**ADDENDA
00 91 13 A-01**

BID FOR: Fort St. John Hospital – CT Scanner Replacement

ADDENDUM No. 1

PROJECT: Fort St. John Hospital CT Scanner Replacement

S1.0

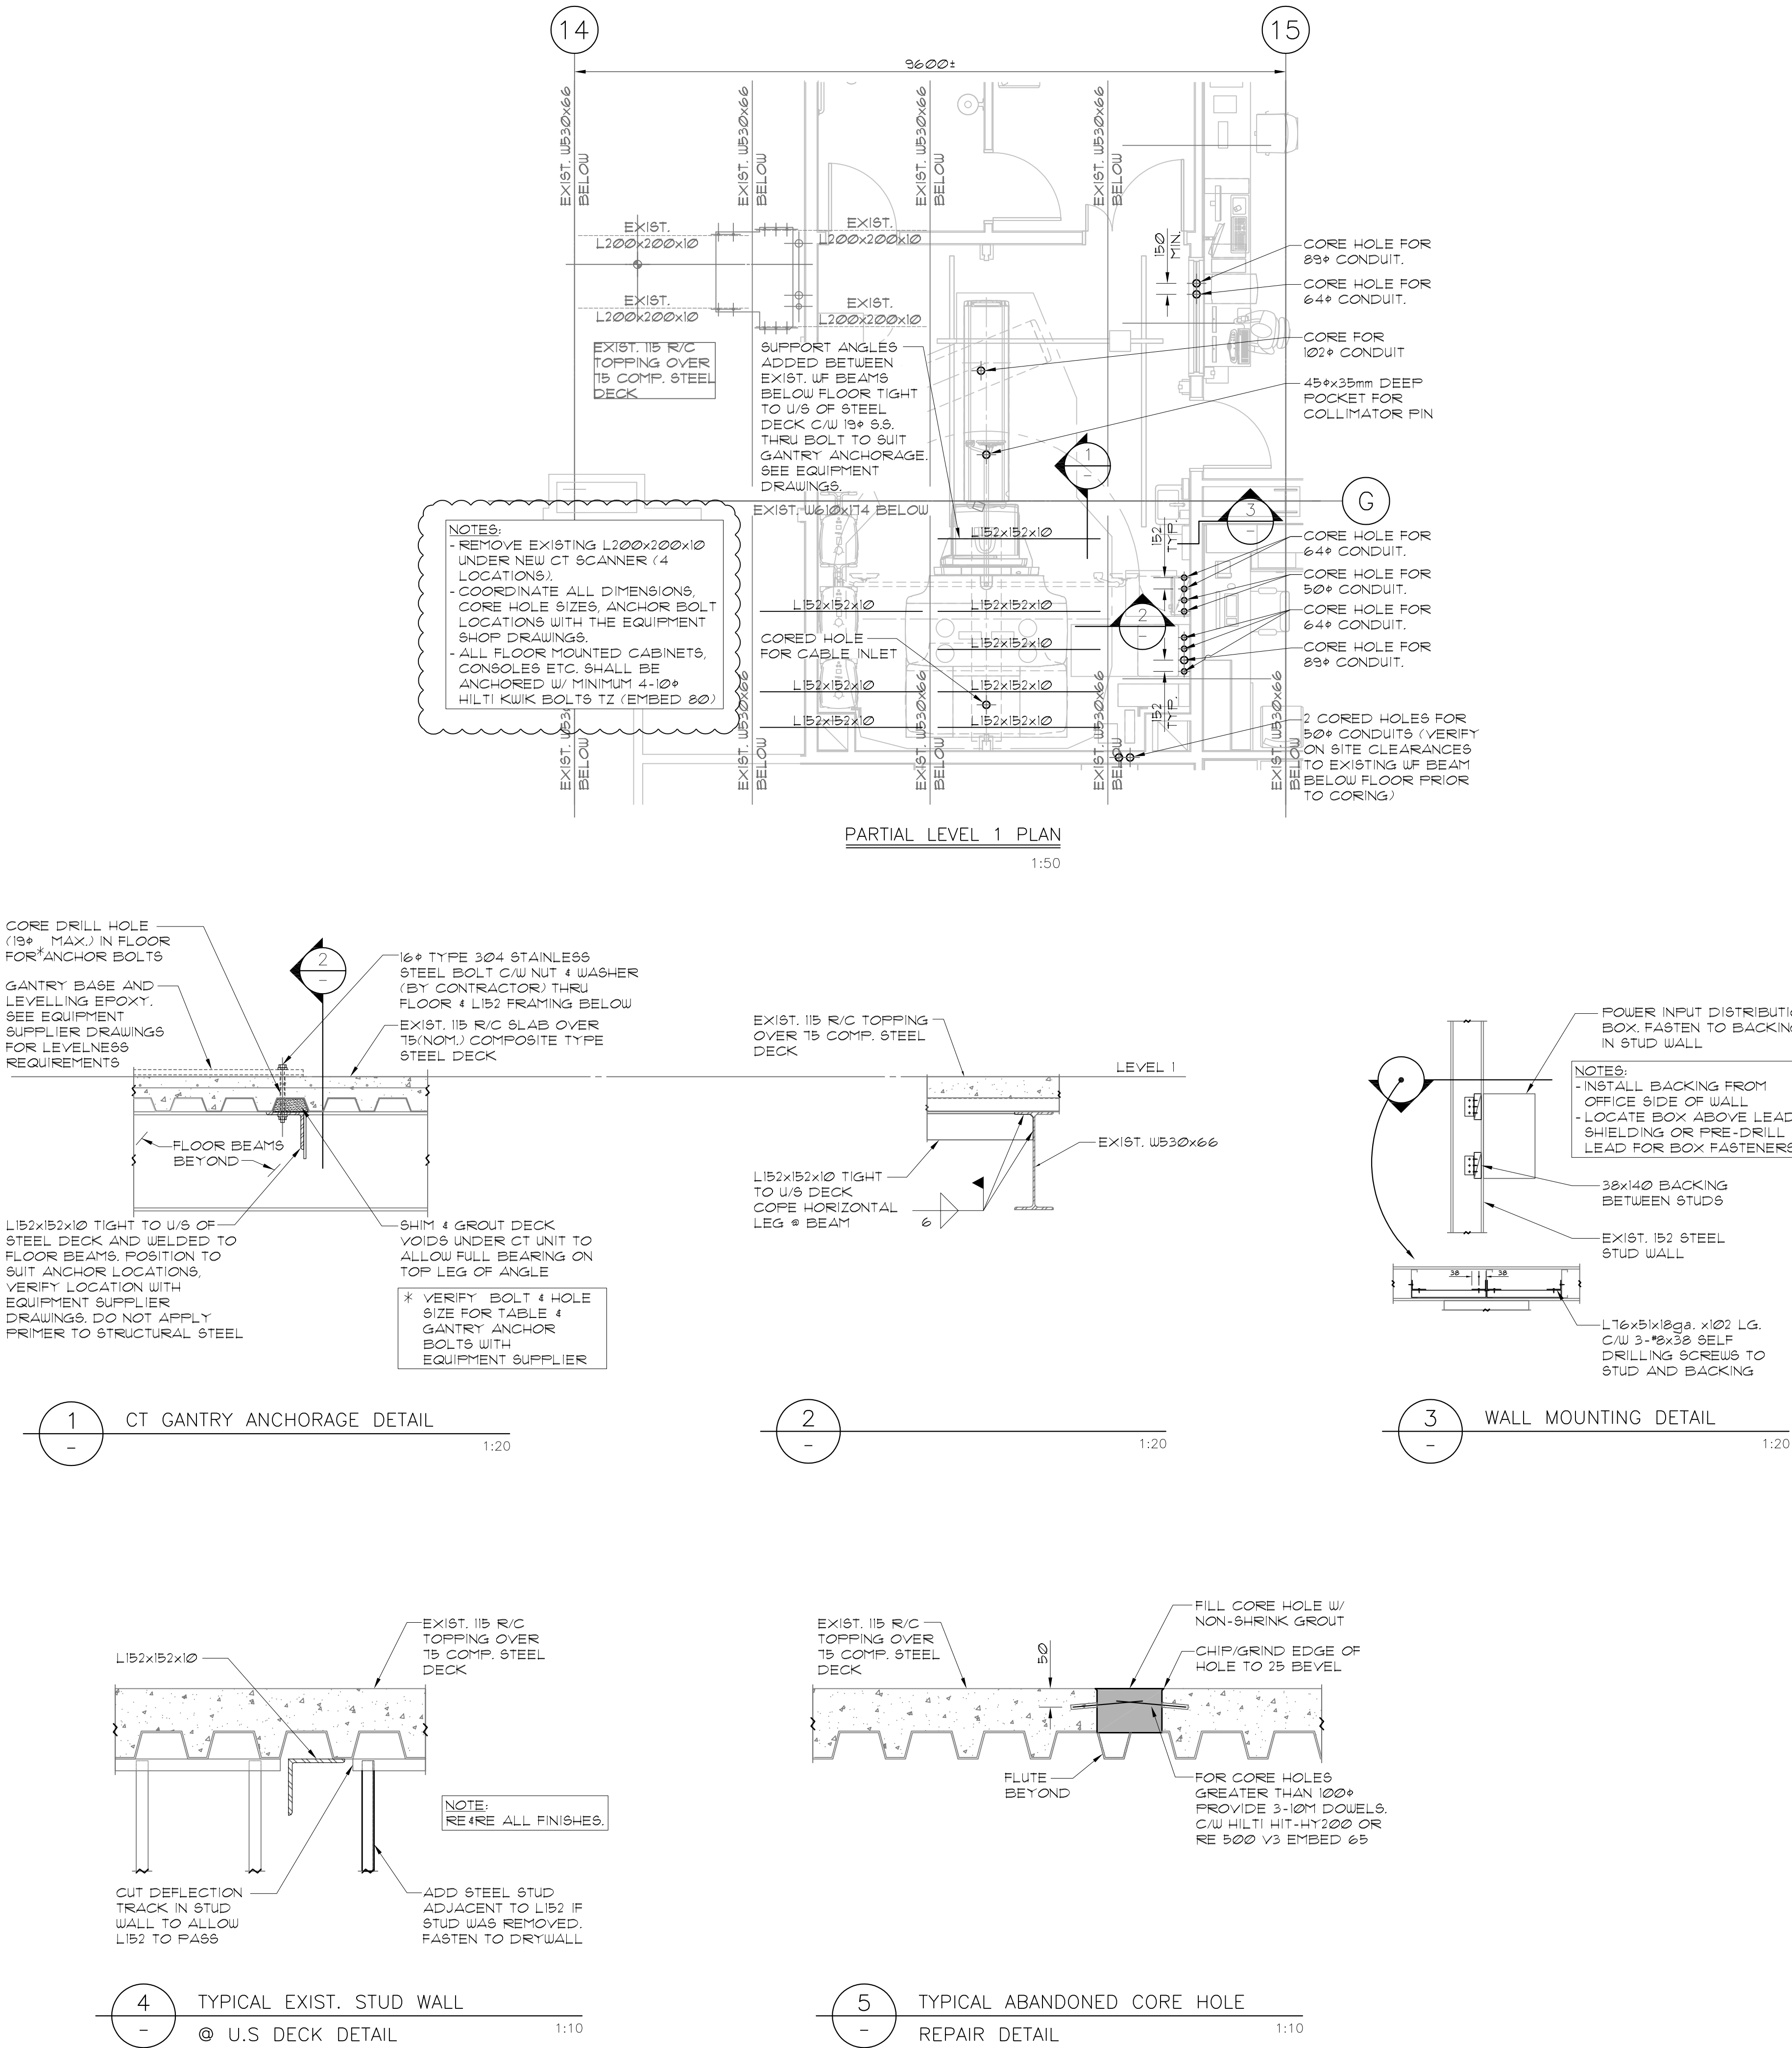
6.1 Question: Can the existing "angled" support angle under existing CT Scanner be re-used, or it does it need to be added to the scope to remove it.

1. Add note to instruct the removal of the existing four L200x200x10 support angles under the new CT scanner.
